14 MILE SLOUGH PUMP STATION UPGRADES

RECORD DRAWINGS
14-Mile Slough Pump Station Upgrades
 TITLE SHEET, VICINITY MAP, SHEET INDEX
 DEPARTMENT OF MUNICIPAL UTILITIES
 CITY OF STOCKTON, CALIFORNIA
 SCALE: NONE
 DESIGNED BY: WYA
 DRAWN BY: DTD
 CHECKED BY: PDF
 RECORD Dwg.:
 SHEET No. **G1**
 1 of 89 SHEETS
 PROJECT No. 293-00-05-01

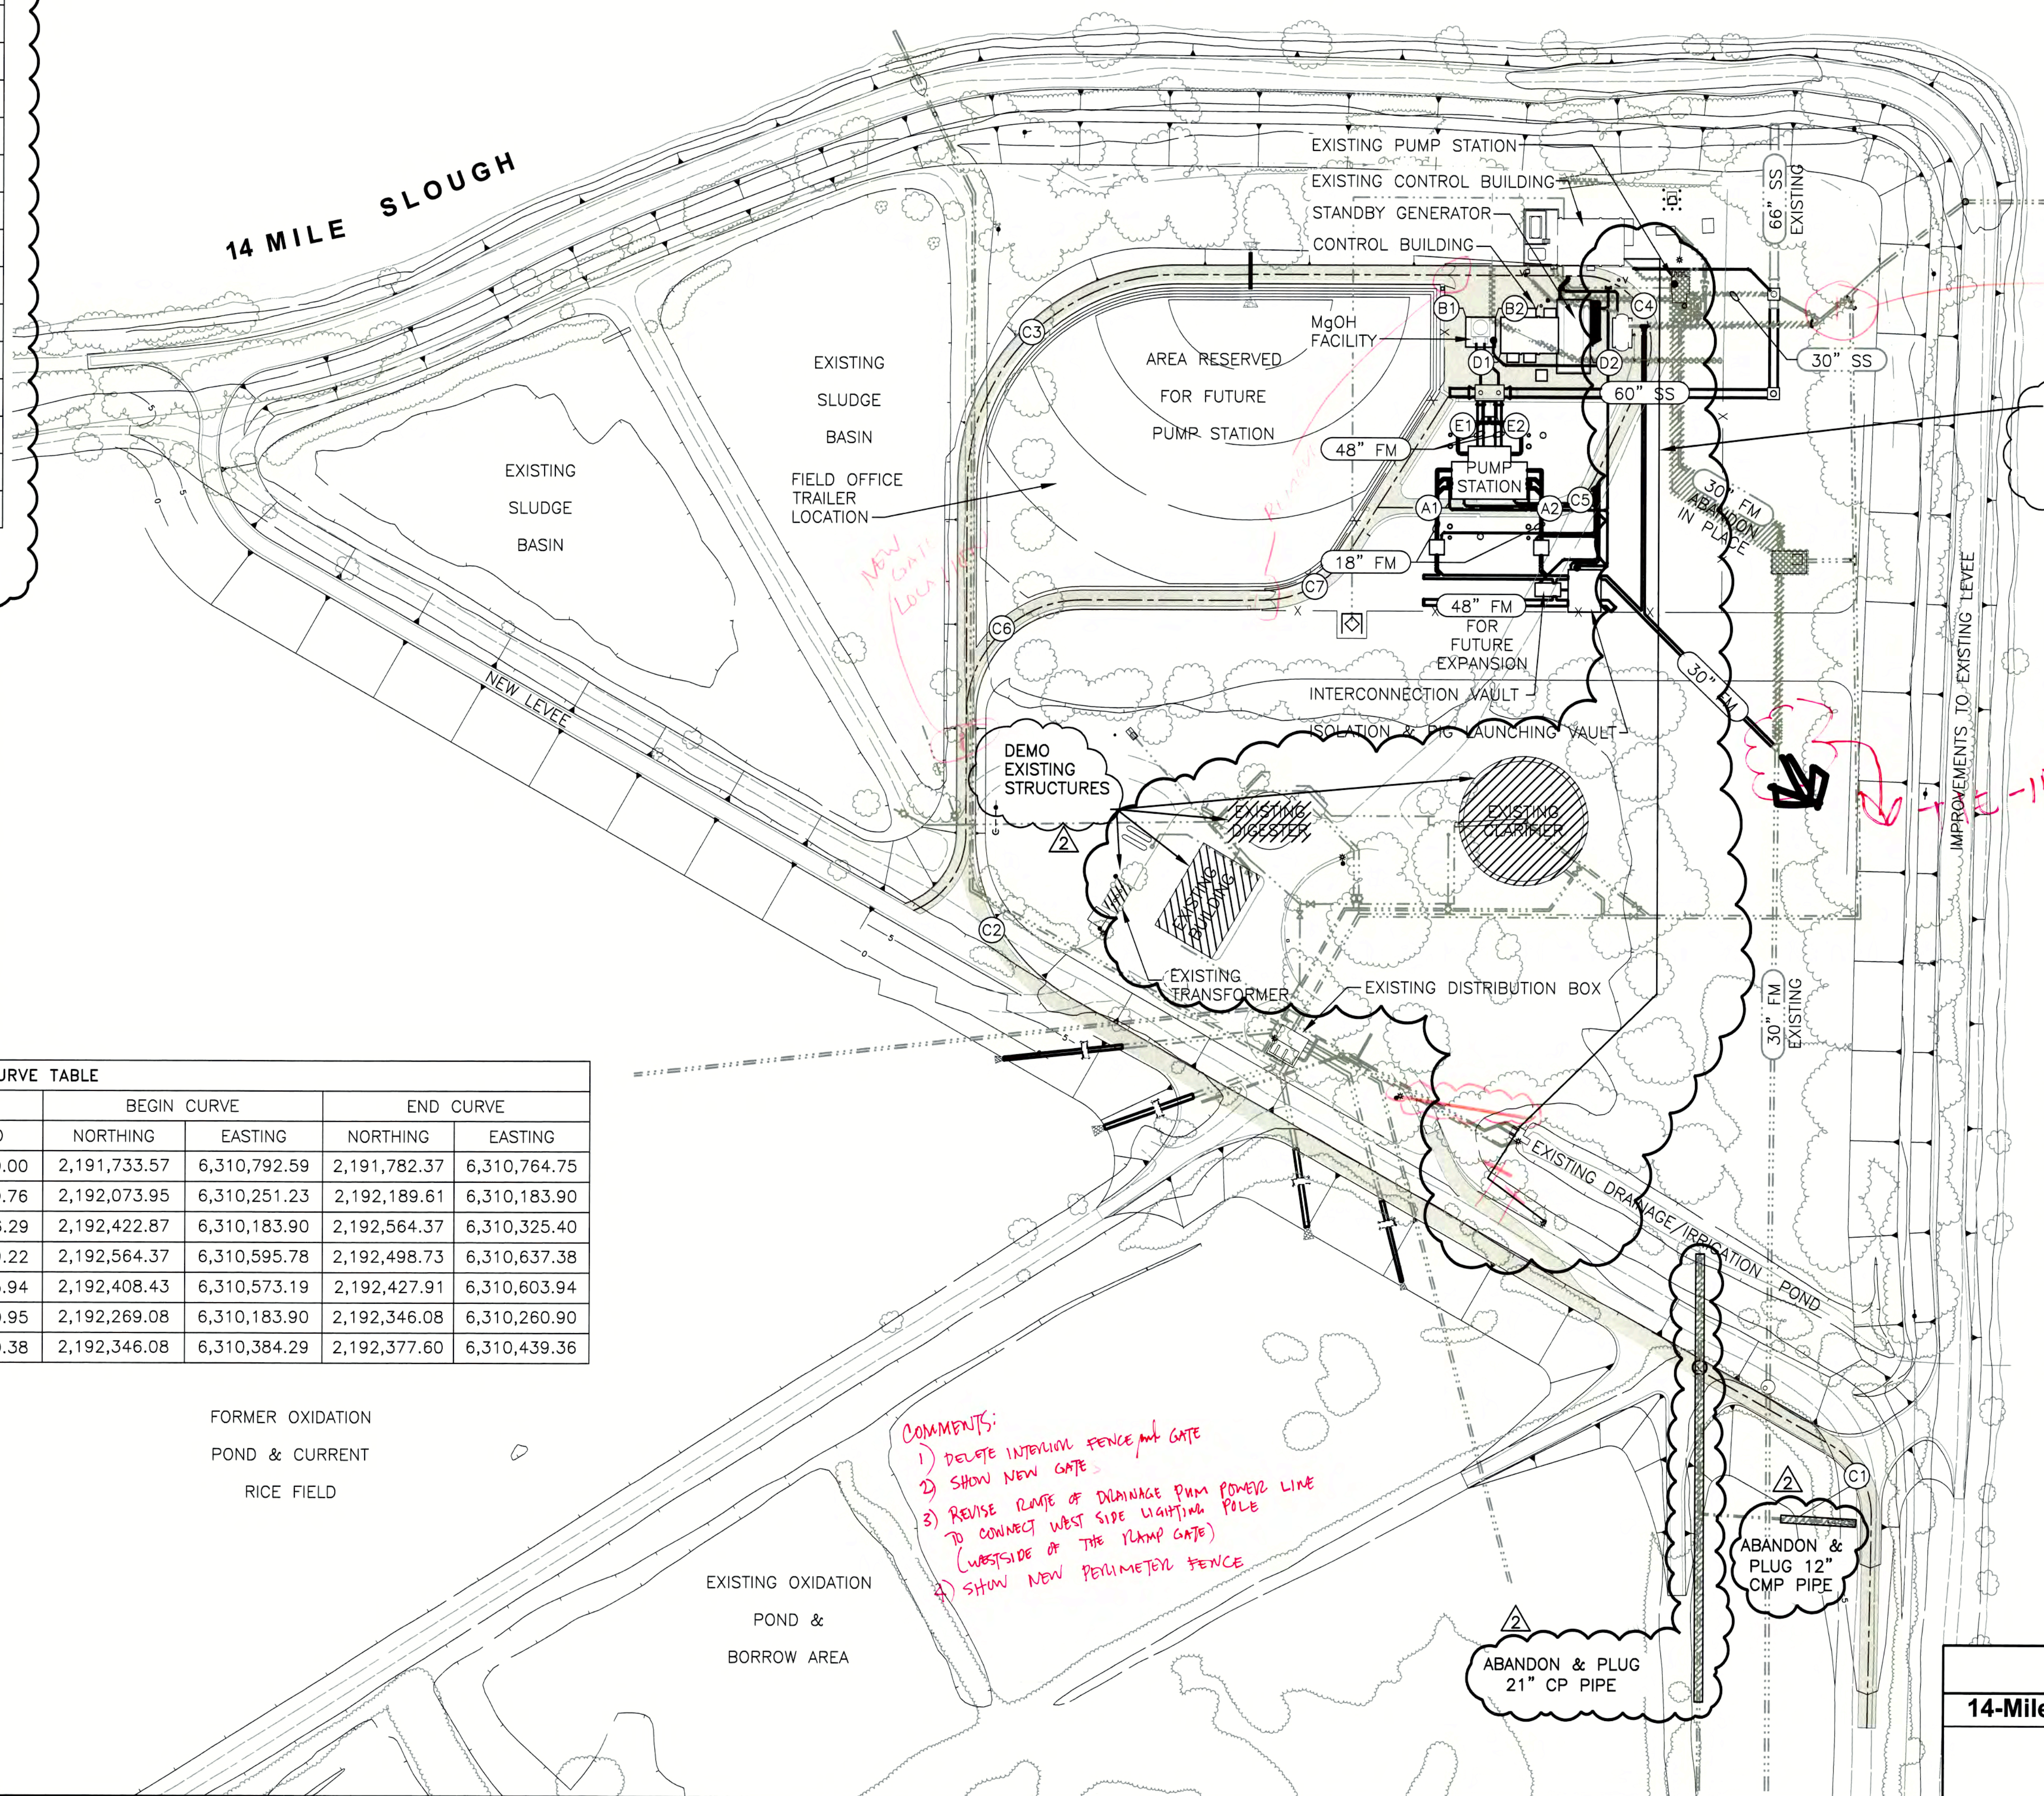
- COMMENTS:
- 1) DELETE INTERIOR FENCE AND GATE
 - 2) SHOW NEW GATE
 - 3) REVISE RANGE OF DRAINAGE PUMP POWER LINE TO CONNECT WEST SIDE LIGHTING POLE (WESTSIDE OF THE RAMP GATE)
 - 4) SHOW NEW PERIMETER FENCE

YARD PIPING PLAN 1

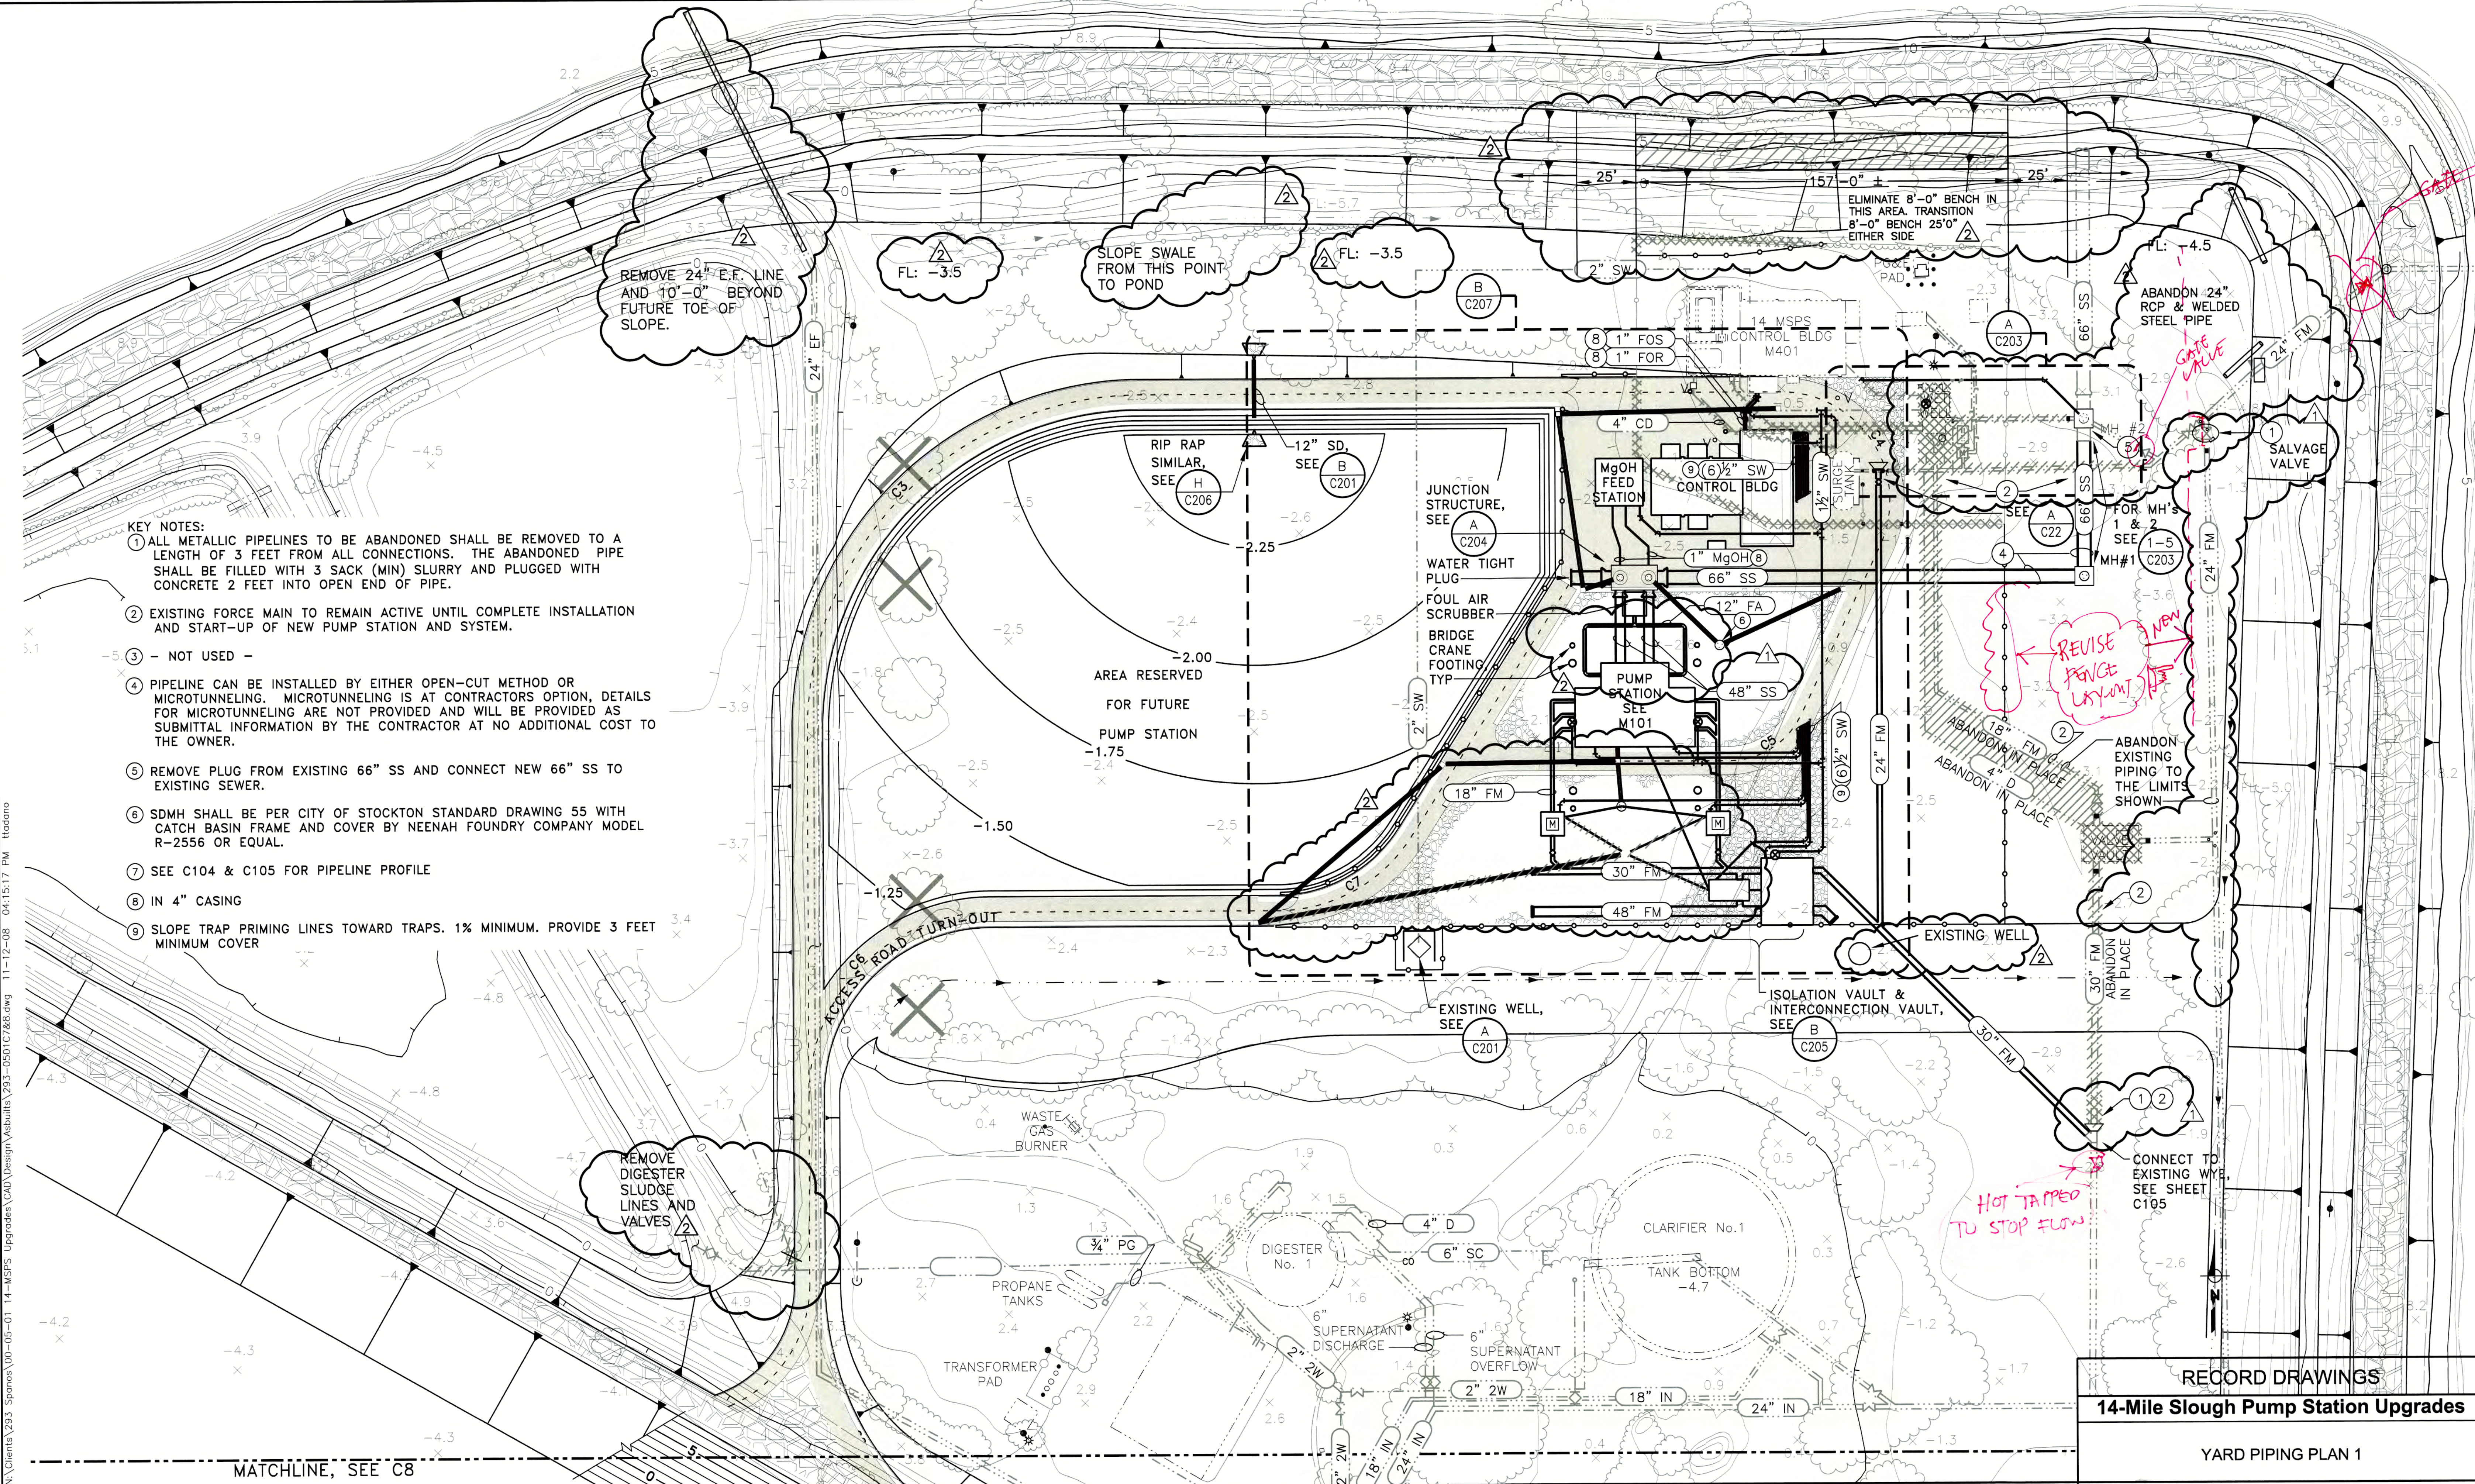
REVISE FENCE LAYOUT
